PCN-20201012 KK0808-03 to KK0808-05 Hardware Revision Change

Company	Trenz Electronic GmbH
PCN Number	PCN-20201012
Title	KK0808-03 to KK0808-05 Hardware Revision Change
Subject	Hardware Revision Change
Issue Date	2020-10-28

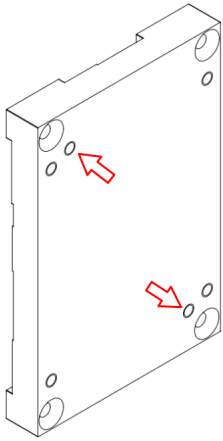
#2 Added two more M3 mounting holes.

Type: Hardware change

Reason: Make compatible to an active cooler of the shelf.

Impact: The Heatspreader is compatible with SZ05L from RADIANT HEATSINKS.

Models with 2 additional threads are revision 05.
